SITE AUDIT REPORT

ENVIRONMENTAL

MANAGEMENT PLAN,

EASTERN PORTION OF

Figure 9.1: Summary of A5 GasfluX results (Source: LFGDA)

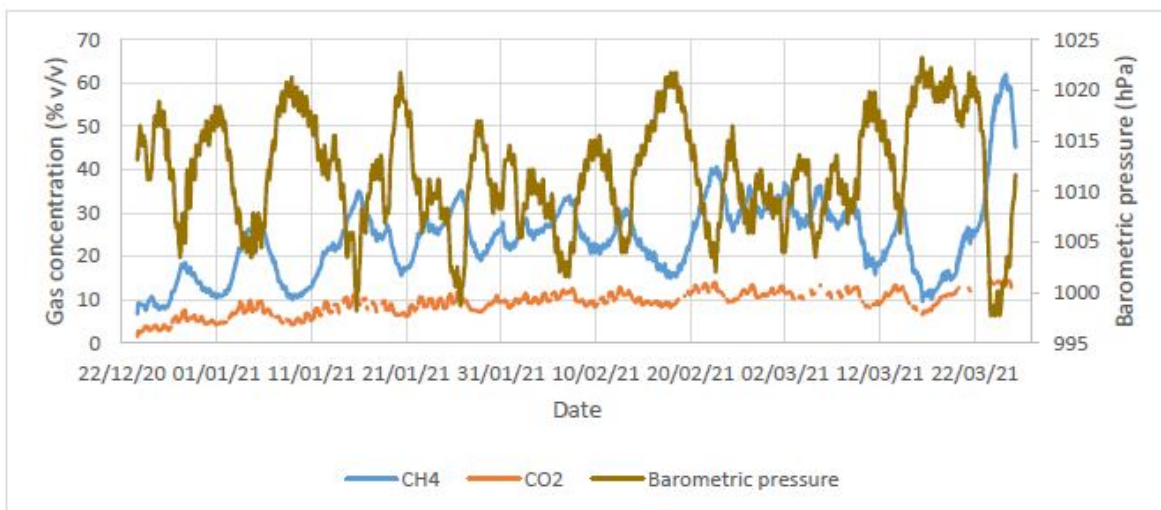
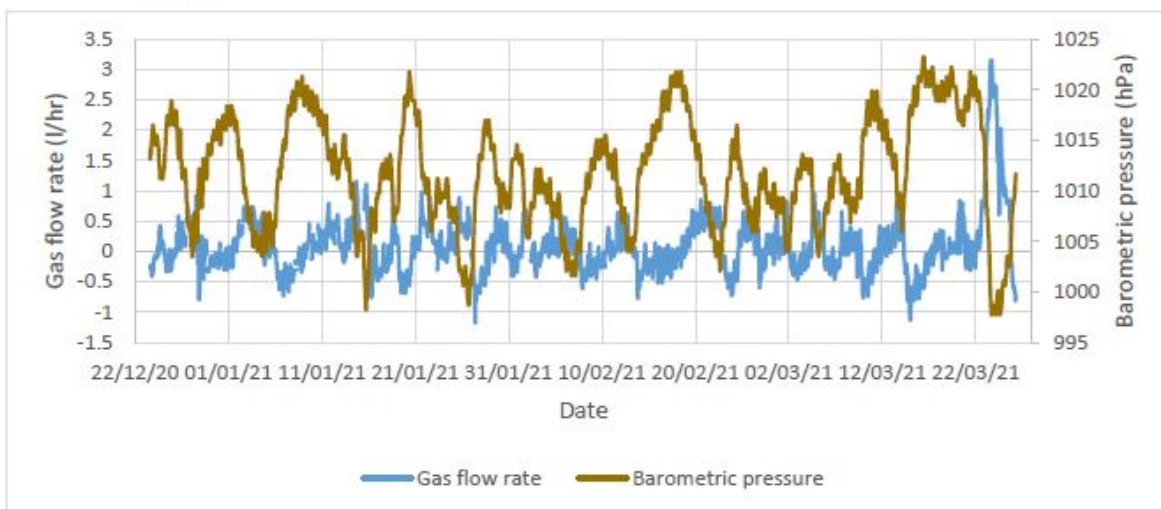
Figure 9.1 indicates that methane concentrations and gas flow rates were at their greatest during or immediately after periods of falling barometric pressure. Carbon dioxide concentration trends reflect methane trends. Methane concentrations and gas flow rates were observed to reach their peaks during the largest and most sustained drop in barometric pressure which occurred at the end of the monitoring period. These peaks were also directly after a period of heavy rainfall, which would be expected to saturate surface soils and increase the tendency for lateral migration of LFG.

Figure 9.2: Summary of A10 GasClam results (Source: LFGDA)

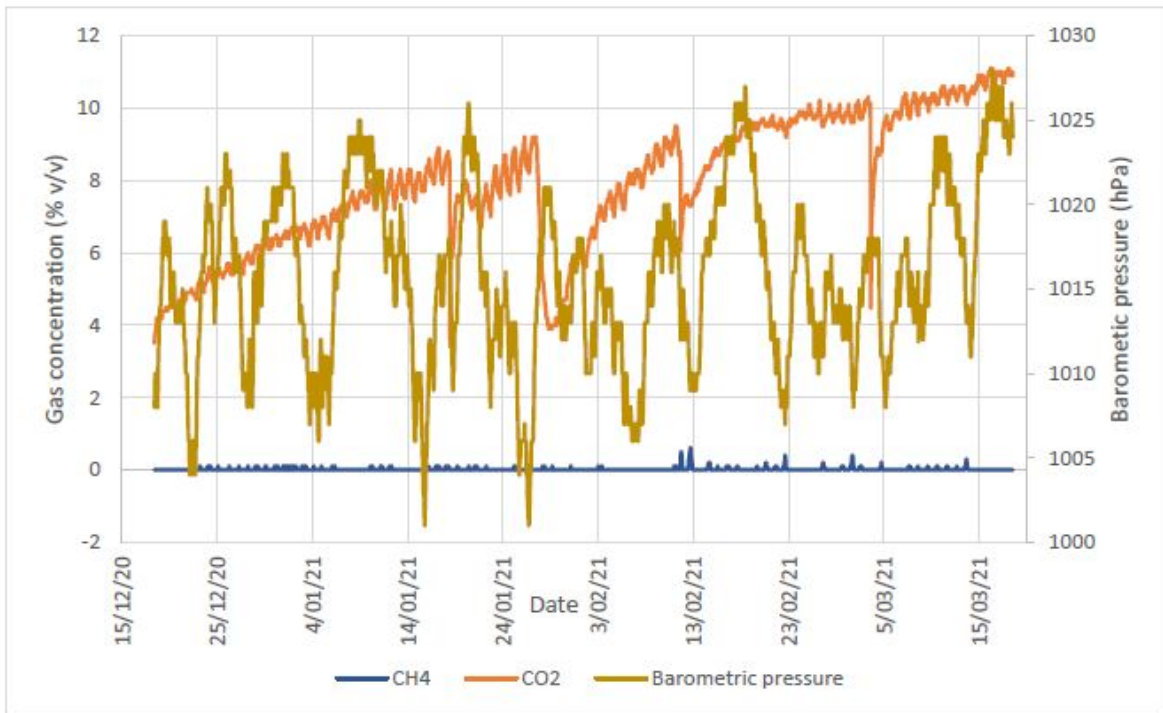
Figure 9.2 indicates methane concentrations in well A10 were insignificant in comparison with carbon dioxide concentrations, which showed an overall increasing trend over the period of monitoring. GHD indicated that the main fluctuations in carbon dioxide concentrations generally corresponded with removal of the GasClam for battery changes where the well would have vented and concentrations slowly increased after the well was re-sealed. The duration of recovery appears proportional to the duration of venting which GHD suggests indicates that carbon dioxide generation rates are relatively low, and may be due primarily to bacterial oxidation within the soil profile (of natural compounds as well as methane) rather than pressure-driven migration from the former landfill. GHD indicates that the slower drop in carbon dioxide concentrations on 27 – 28/01/2021 was not due to a battery change and was likely due to rising barometric pressures at that time, resulting in negative flow conditions.
